# City of Sandy

### Planning Commission Meeting

**Meeting Date:** Tuesday, December 3, 2019

LANDSCAPE PLAN

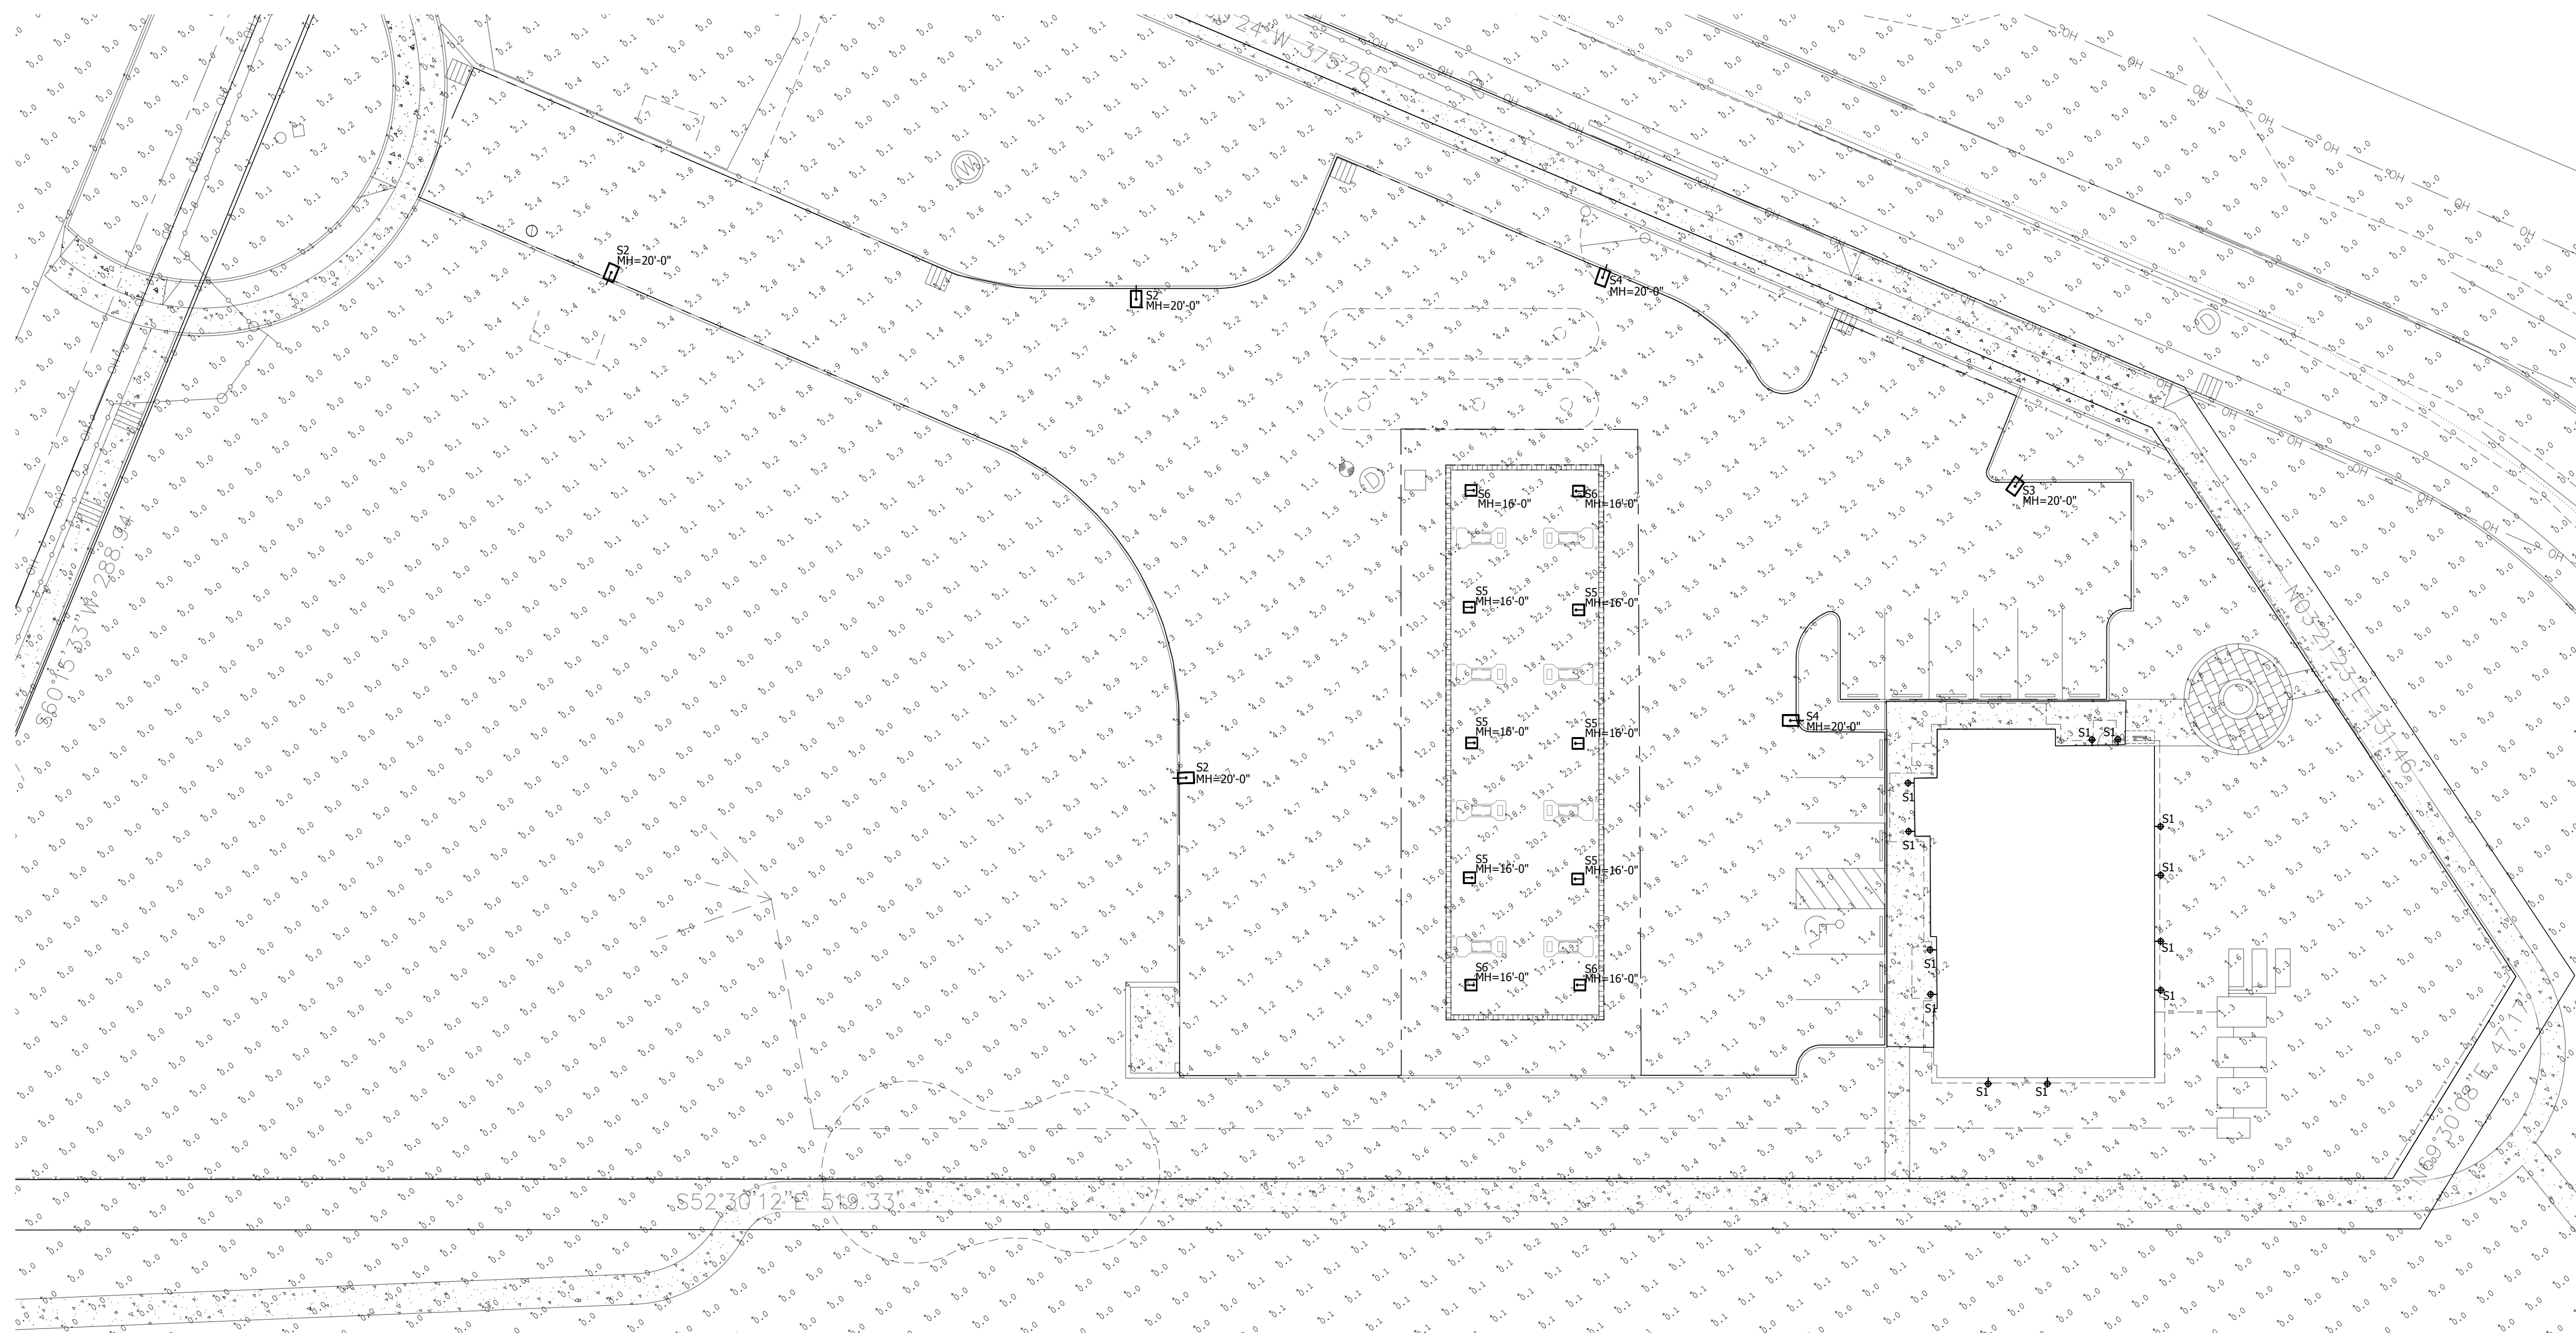
~~102~~109. Section 17.98.120(F) requires wheel stops or other methods to protect landscaped areas. The plan set details wheel stops in the parking areas directly north and west of the convenience store. The Landscape Plan (Exhibit D, Sheet L-101) details curb in the westernmost parking row, which is proposed to be adjacent to a walkway once the future building is built; however, will be adjacent to landscaping until the future building is built. **The applicant shall update the plan set to detail wheel stops in the westernmost parking row to protect landscaping and future walkways.**

- Detail 10 large street trees or 17 medium street trees along the Highway 26 frontage of the site. The applicant shall submit details on the proposed street tree species and locations for staff review and approval. The applicant shall obtain a permit from ODOT to place trees within the highway right-of-way.

A-221

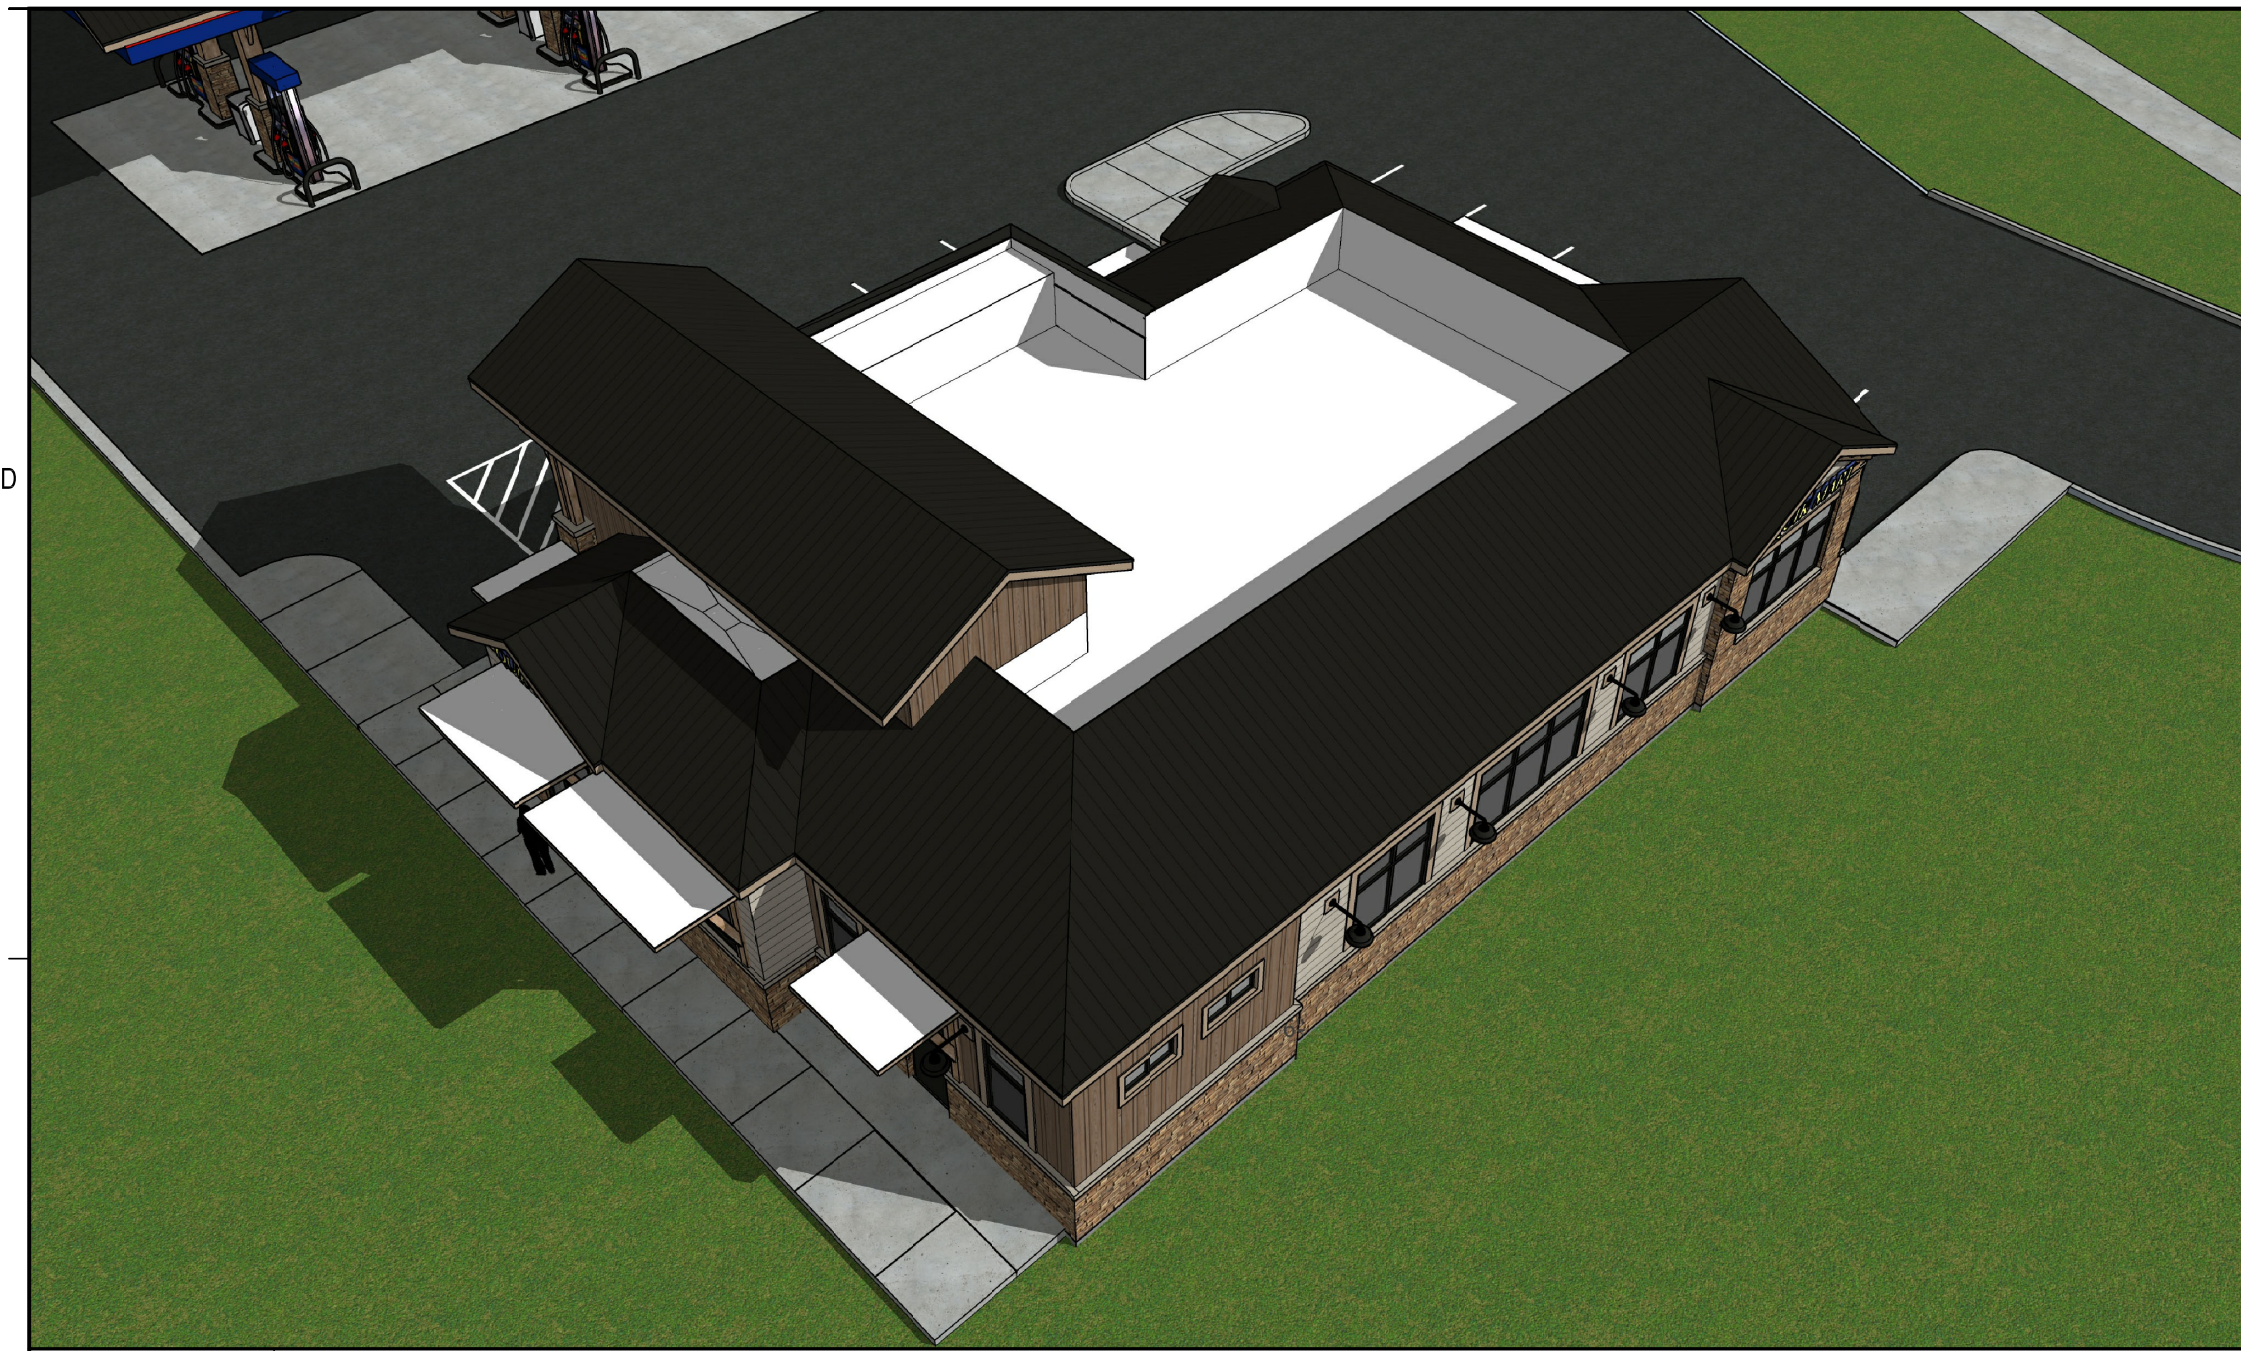
Staff recommends the Planning Commission require the applicant to update the plan set to detail 5 foot deep minimum pedestrian shelters over the walkways abutting the proposed convenience store building on the south, west, and north elevations as well as over the civic space.

~~38-42.~~ Section 17.90.120(B.1.a) requires that all elevations visible from an abutting public street or pedestrian walkway shall be divided into distinct planes of not more than 40 lineal feet. All four elevations exceed 40 lineal feet and, therefore, require a variation in the wall plane that includes a recessing or projecting section that projects or recedes at least six inches from the adjacent plan for a length of at least four feet. The submitted elevations (Exhibit E, Sheets A220-222) detail a projection/recession along the east, west, and south elevations, and a shed roof pedestrian shelter overhang feature along the north elevation in compliance with this section.

Staff recommends the Planning Commission require the applicant to update the plan set to detail 5 foot deep minimum pedestrian shelters over the walkways abutting the proposed convenience store building on the south, west, and north elevations as well as over the civic space.
